PLANNING AND ZONING CASE CHECKLIST

P&Z CASE # 22021-007 P&Z DATE 04/13/21 CC DATE 04/19/21 APPROVED/DENIED _____
ARCHITECTURAL REVIEW BOARD DATE _____ HPAB DATE _____ PARK BOARD DATE _____

PROJECT NUMBER: Z2021-007
PROJECT NAME: Zoning Change from AG to PD (Klutts Family Farm)
SITE ADDRESS/LOCATIONS:

03/24/2021: Z2021-007; Zoning Change (AG to PD) for Klutts Family Farm
Please address the following comments (M= Mandatory Comments; I = Informational Comments)

CONCEPT PLAN
OF
HOMESTEAD
SITUATED IN THE
J.A. RAMSEY SURVEY, ABSTRACT NO. 186
IN THE
CITY OF ROCKWALL
ROCKWALL COUNTY, TEXAS
PREPARED BY
CORWIN ENGINEERING, INC.
200 W. BELMONT, SUITE E
ALLEN, TEXAS 75013
972-396-1200
OWNER
KLUTTS FARM, LLC.
1604 NORTH HILLS DR.
ROCKWALL, TX 75087

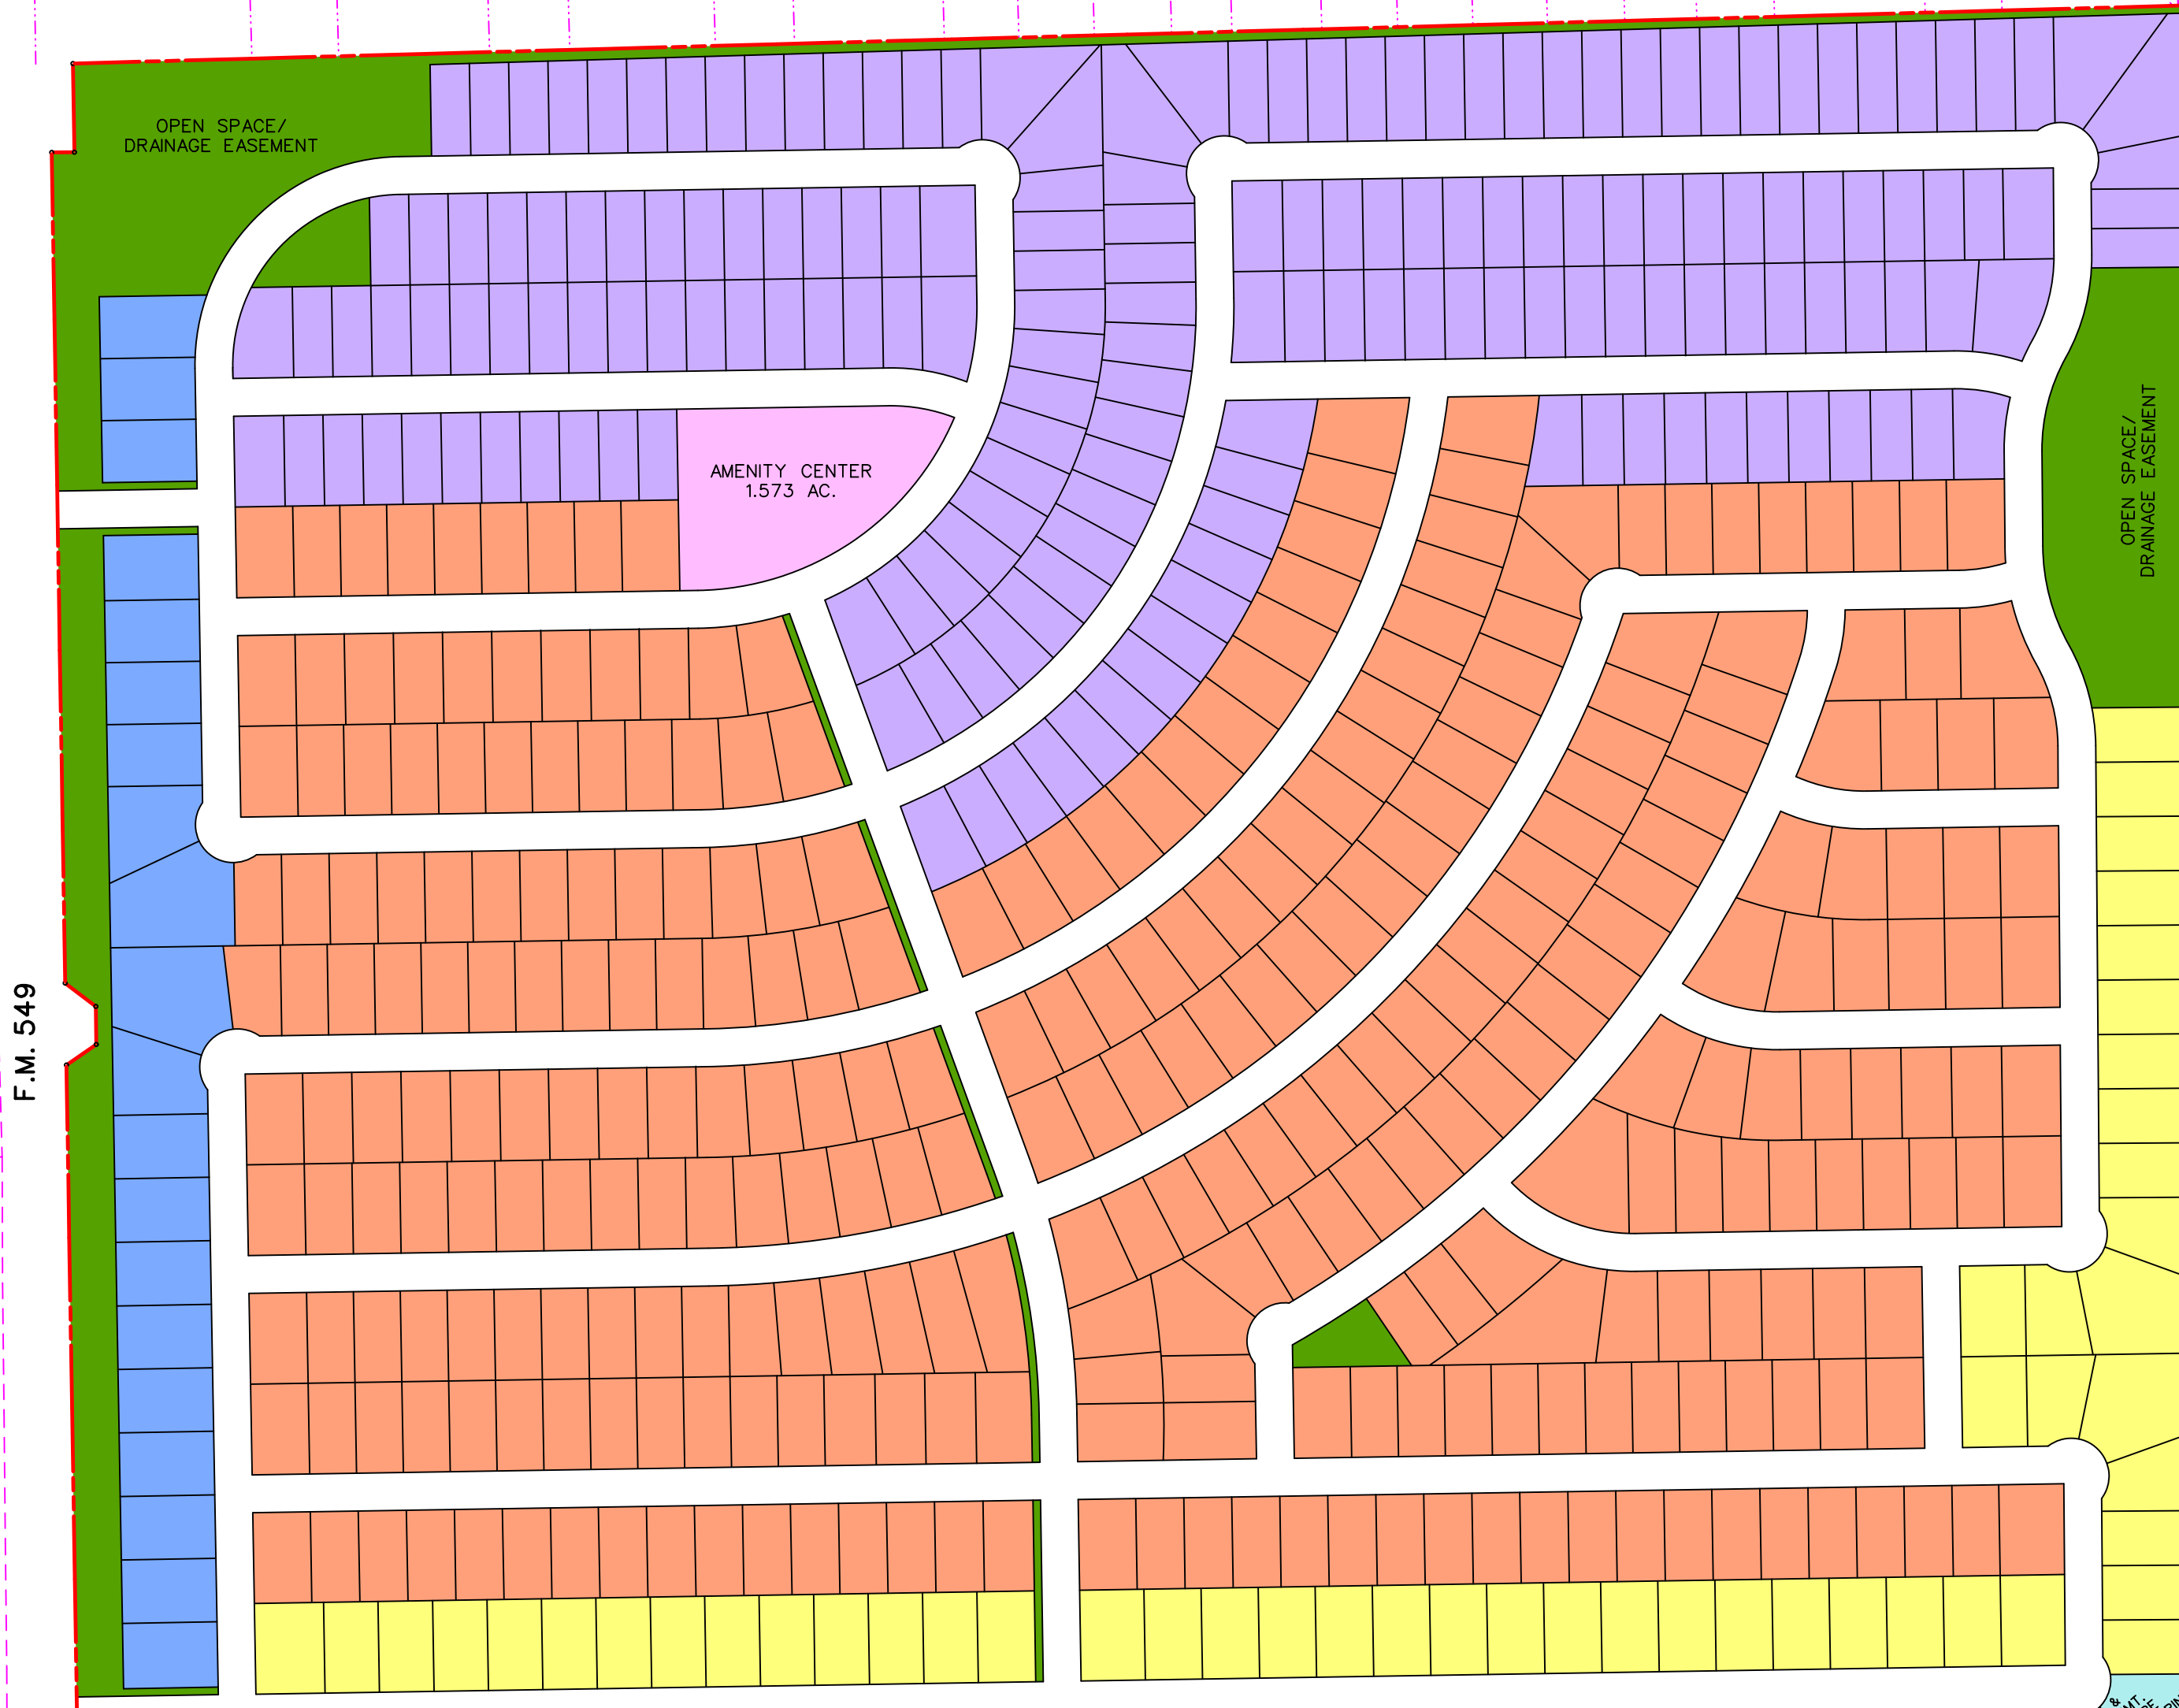
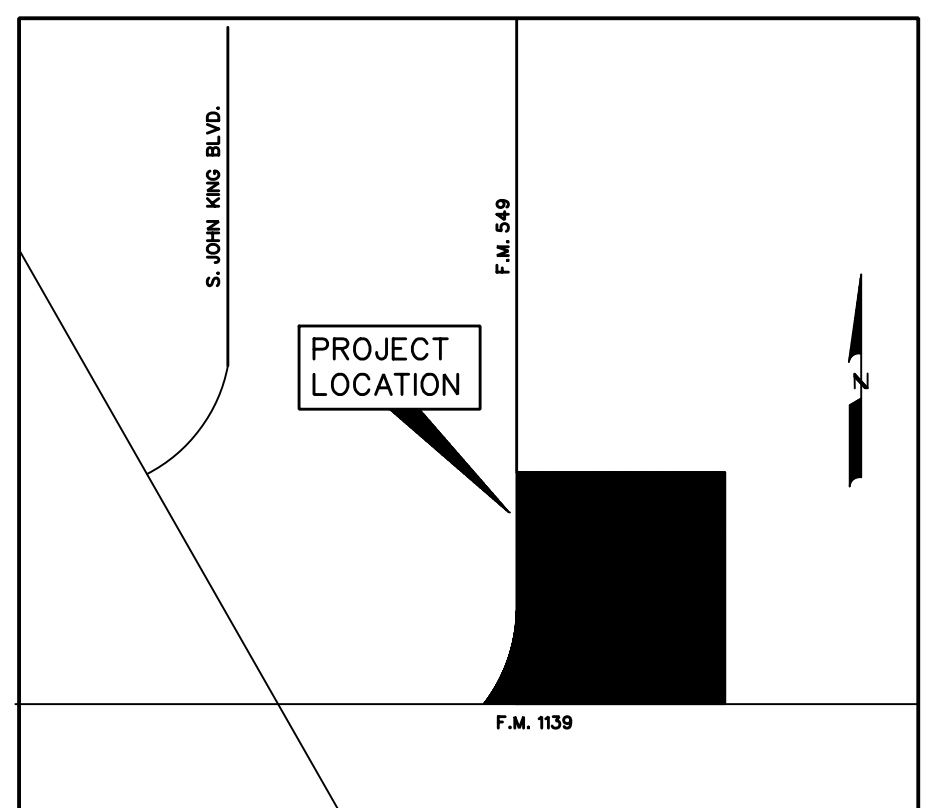
M.7 According to the OURHometown Vision 2040 Comprehensive Plan, the proposed development deviates from the residential goals and policies in the following ways:

Staff Response: Consider putting the smaller 62' x 120' lots fronting on to the park land area, and moving the 72' x 120' lots elsewhere in the development.

Staff Response: A trail system should be incorporated into the development that links the private open space areas to the proposed public park. Staff will require a hardscape plan showing the trail locations with the PD Site Plan.

Staff Response: Consider removing the 52' x 120' lot product as it does not adhere to the goals and policies of the Comprehensive Plan.

- (1) Remove Table 2: Lot Dimensional Requirements and all notes from the zoning exhibit.
- (2) Change Regional Park to Public Park. Currently, the City does not have a classification in the Parkland Dedication Ordinance for Regional Park; however, this will be changed with the adoption of changes to the Parkland Dedication Ordinance in the future.
- (3) Remove the drainage and detention easements shown on the zoning exhibit. These have been addressed in the language in the Planned Development District ordinance.

- M - This plan shows 562 lots. Maximum 243 lots are required before the two 3097 Lift Stations will need to be upgraded to ultimate capacity.
- M - The Somerset Lift Station will need to have an infrastructure study done to determine upgrades required to be constructed.
- M - Detention is required.

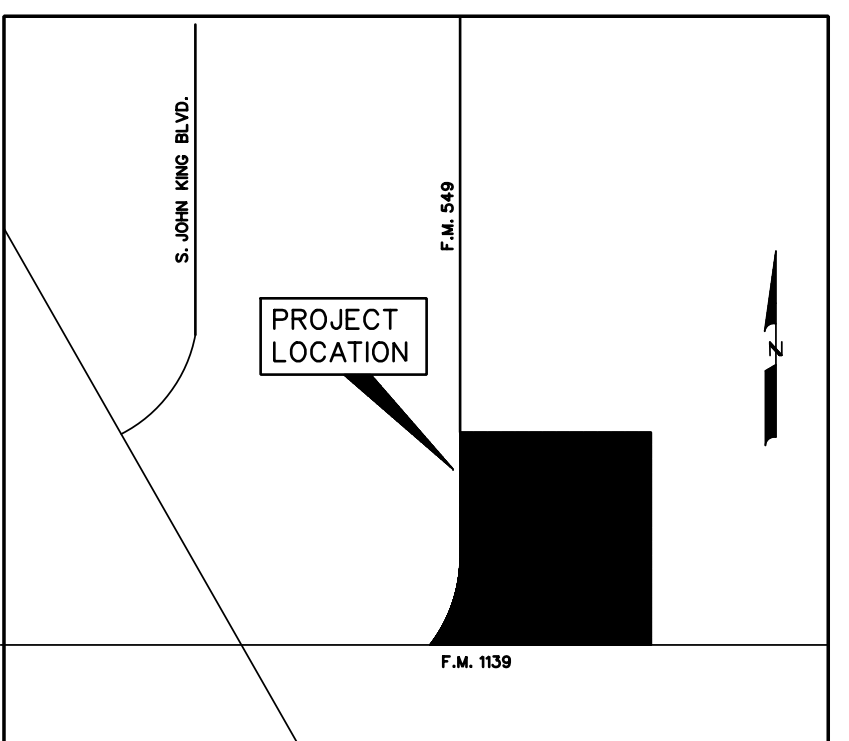
Only 91.83 acres are with the City of Rockwall right to serve water.

- This plan shows 562 lots.
 - The Somerset Lift Station will need to have an infrastructure study done to determine upgrades required to be constructed.
 - Maximum 243 lots are required before the two 3097 Lift Stations will need to be upgraded to ultimate capacity.
